HISTORIC PRESERVATION BOARD

HISTORIC PRESERVATION BOARD MEETING

WORKSHOP
176 EASTERN PROMENADE

TO: Chair Pollard and Members of the Historic Preservation Board
FROM: Rob Wiener, Historic Preservation Compliance Coordinator
DATE: January 5, 2022
RE: January 12, 2022 **WORKSHOP – Preliminary Review of Proposed
Dormer Additions - HPBR-001849-2021**

168 DANFORTH ST.
NORTH ELEVATION

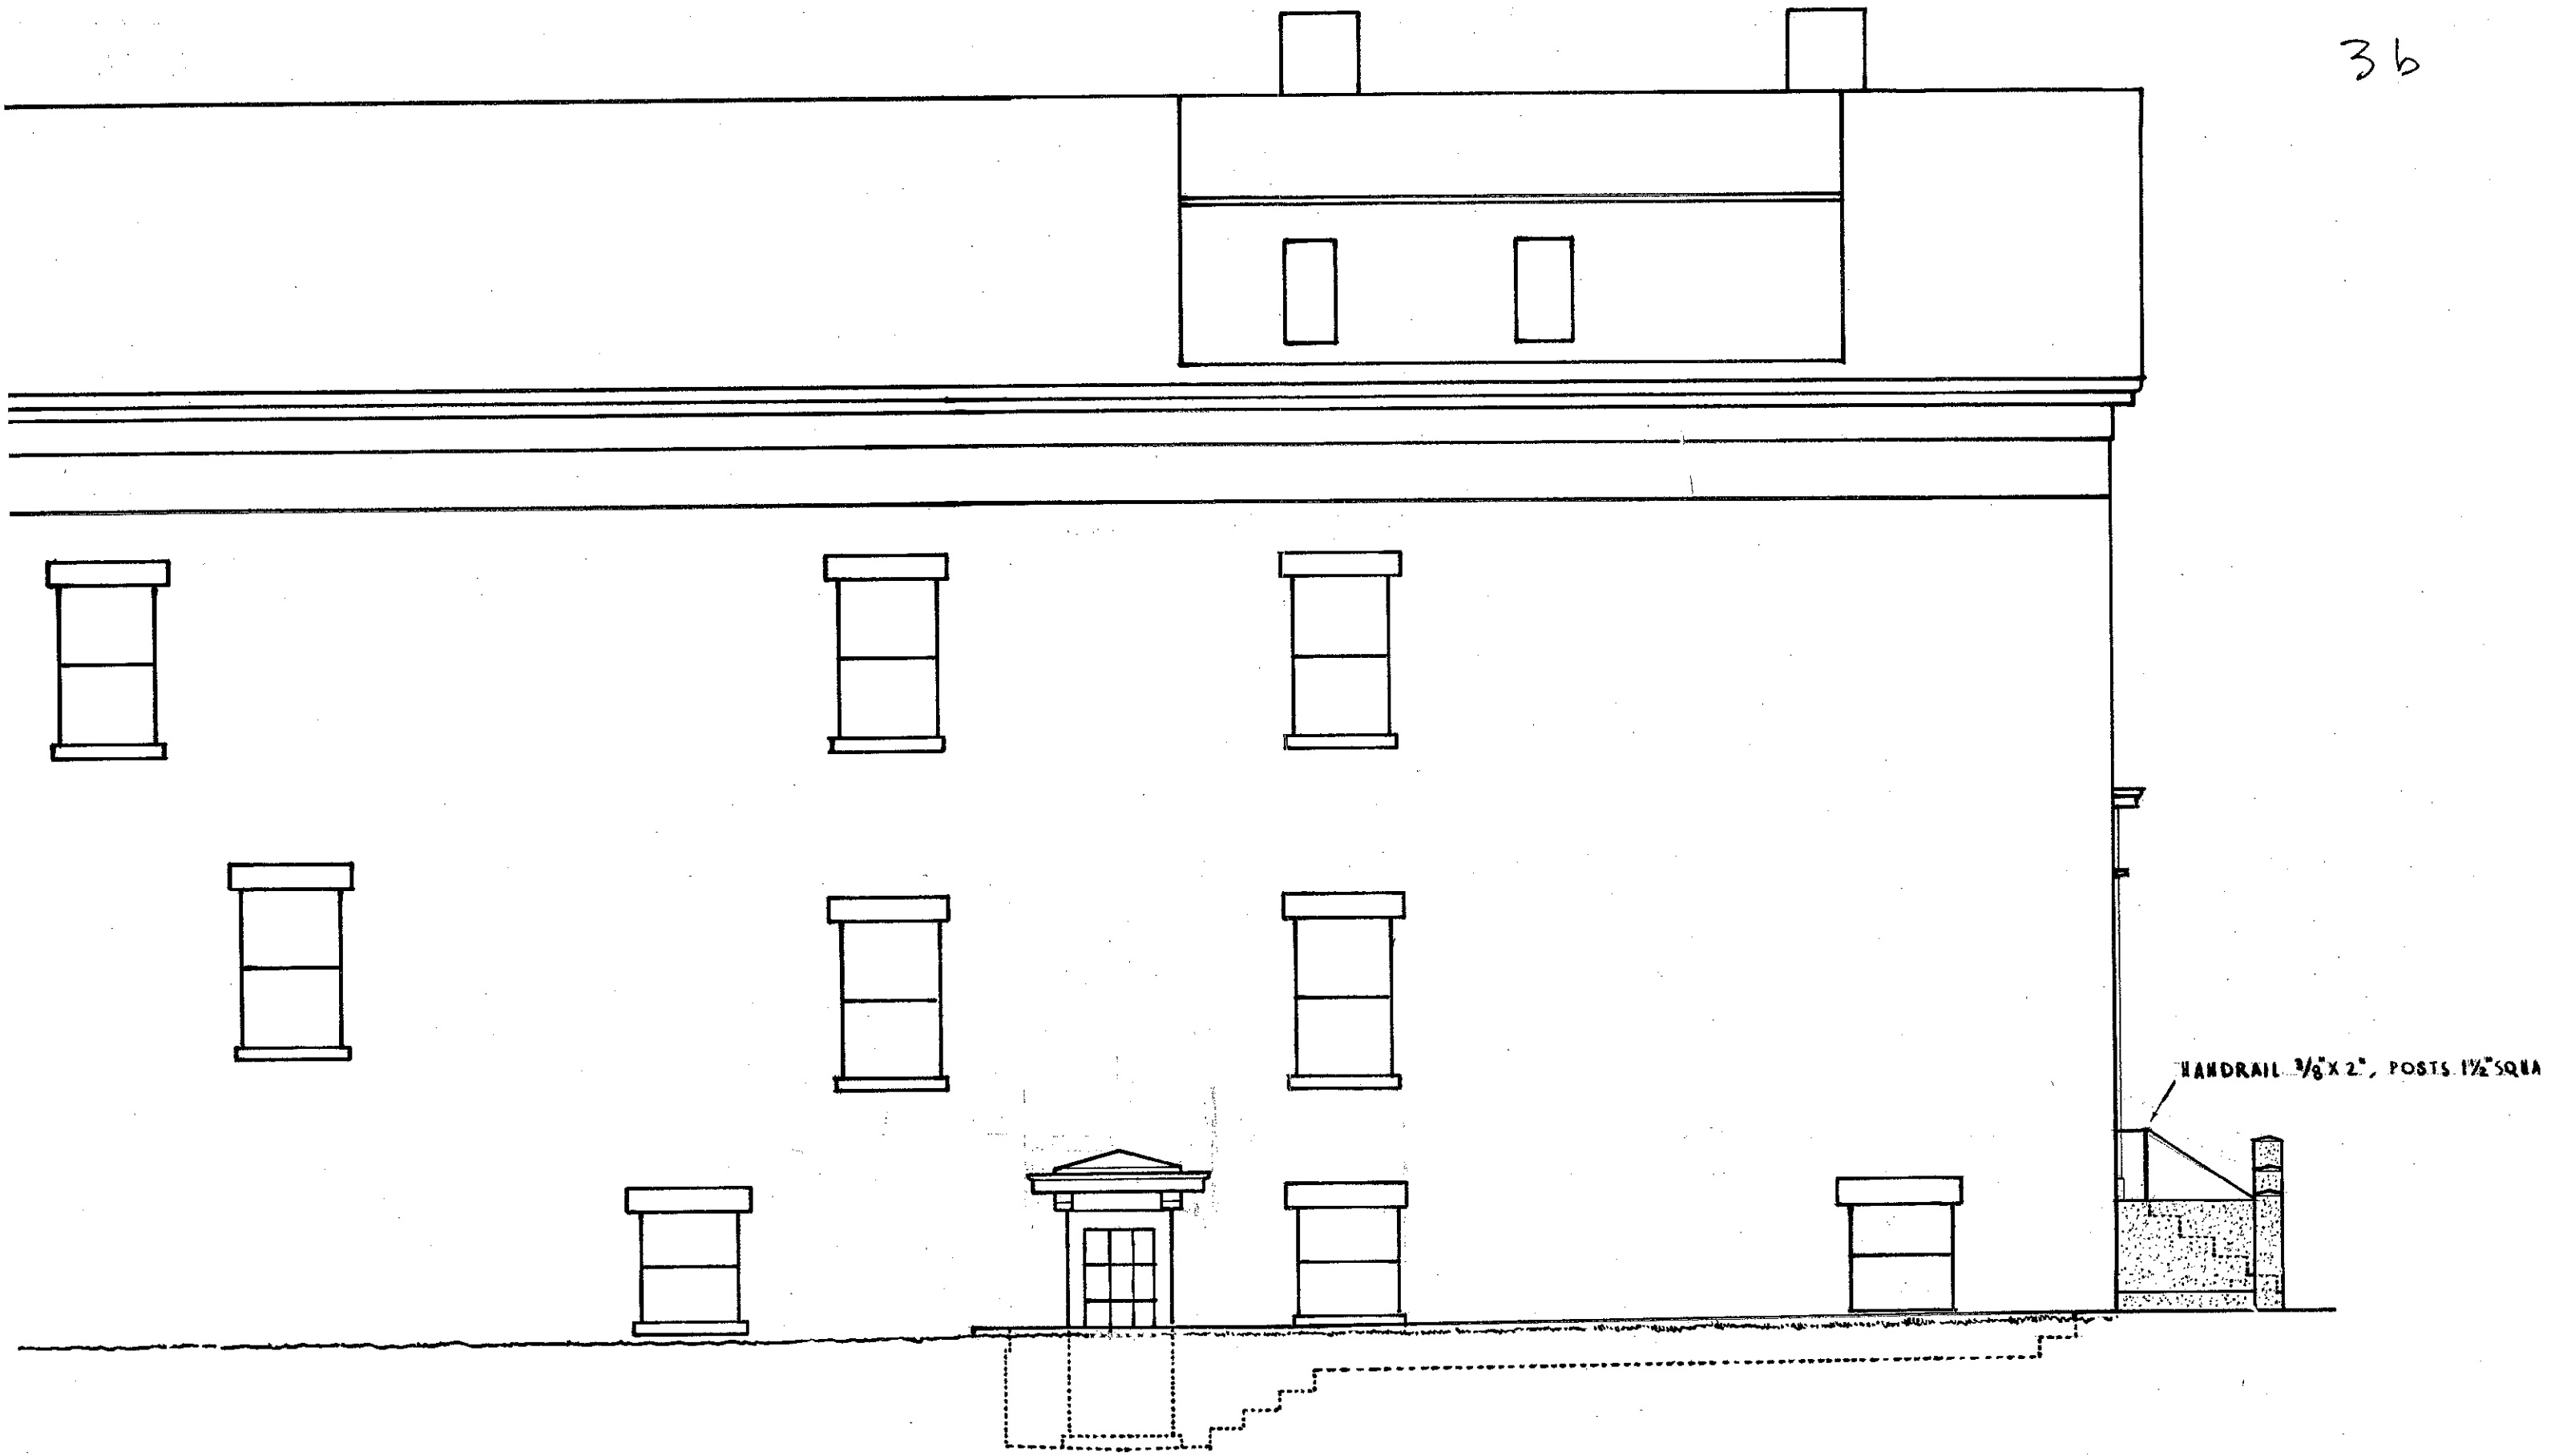
- The granite cheekwalls at the front entrance are straight, not curved, in plan. Note also that the cheekwalls do not follow the line of the stairs, but project horizontally from the front plane of the house.

- The granite posts on either side of the driveway are the same height as those across the front of the house.
- On the east side of the house, the fencing and posts step down, rather than continuing at a level elevation. The design of the iron gate has been modified to reflect the change. *A site visit would be helpful in determining whether or not this stepped effect is a necessary/desirable modification.*

168 DANFORTH ST.
EAST ELEVATION

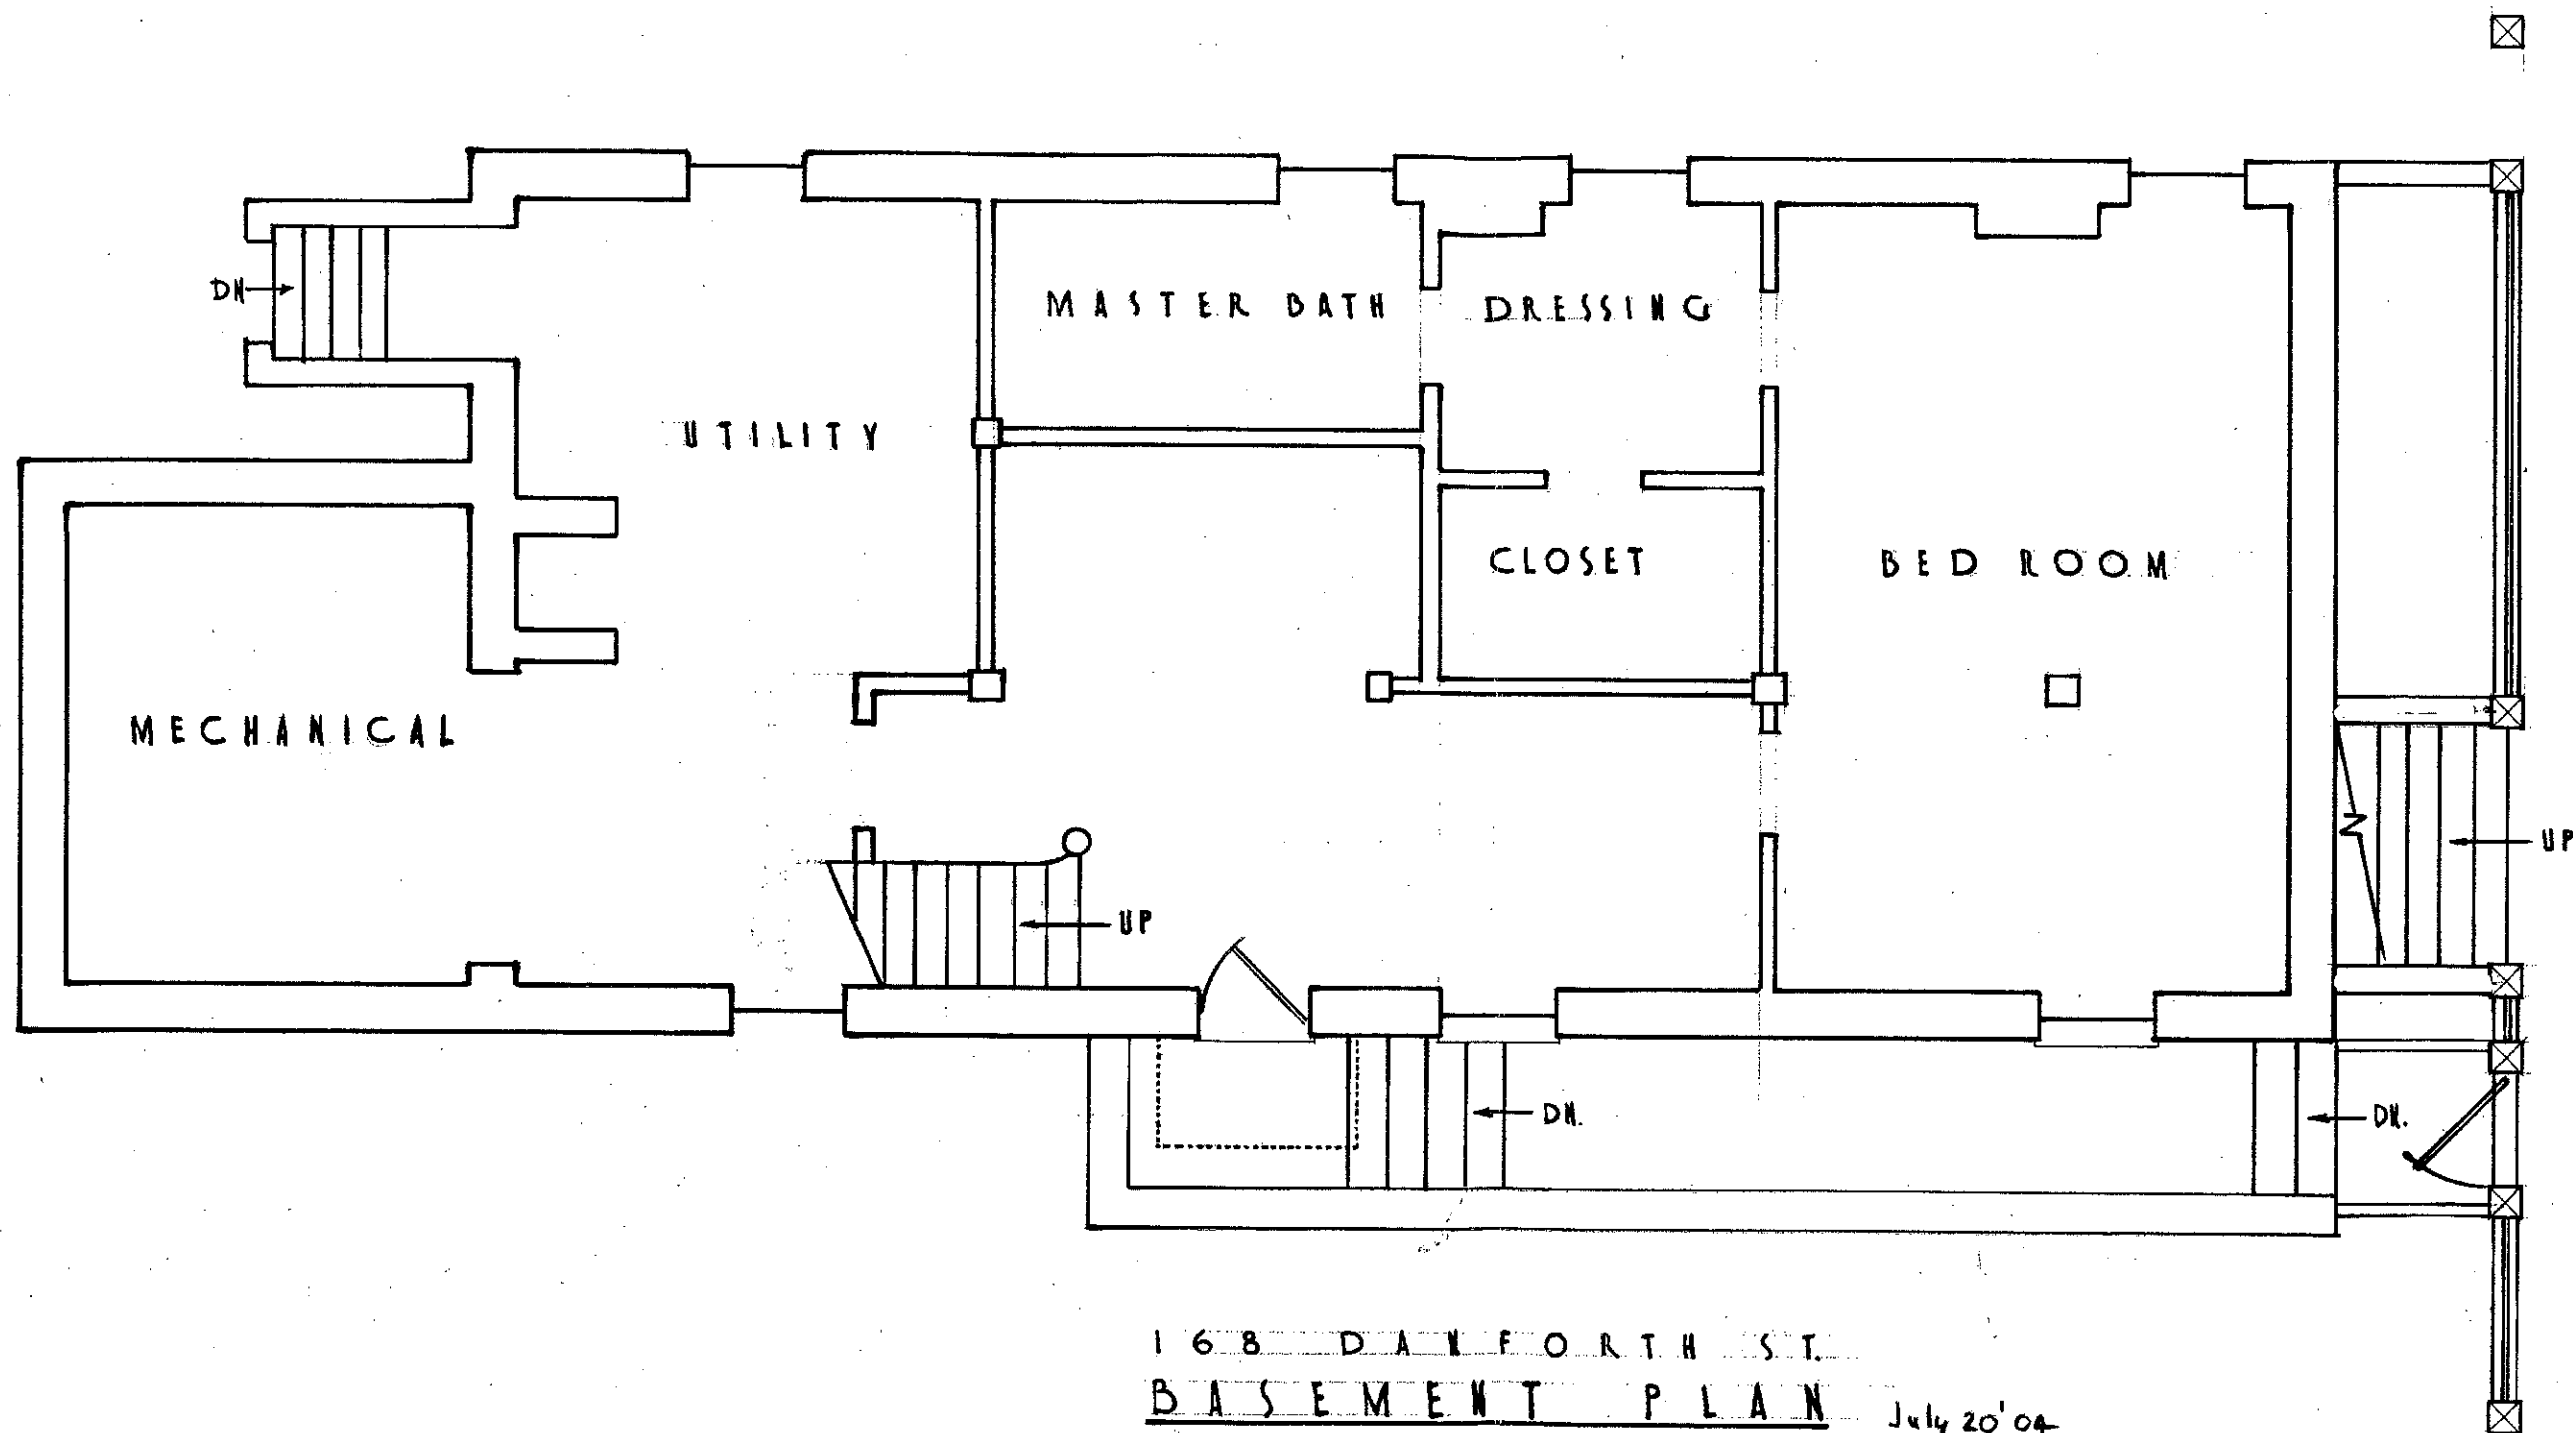
- The hipped portico with supporting columns has been eliminated and replaced with a simpler door hood supported by brackets. *This is similar to the hood installed on the side elevation at 188 Danforth Street – see enclosed photo (Attachment 4). Note that the brackets at 188 include foliate carving. If approved, staff would suggest that the brackets be simpler in detail.*

Regarding the proposed treatment of the exposed foundation, Mr. Taylor is prepared to provide more detail on Wednesday. *Note that the photos of 188 Danforth Street depict a similar alteration, where the foundation has been exposed for a basement-level side entrance—see Attachment 4. Committee members are encouraged to inspect the treatment at 188 Danforth in preparation for this review, as it represents to a large degree how the proposed alteration will appear.*
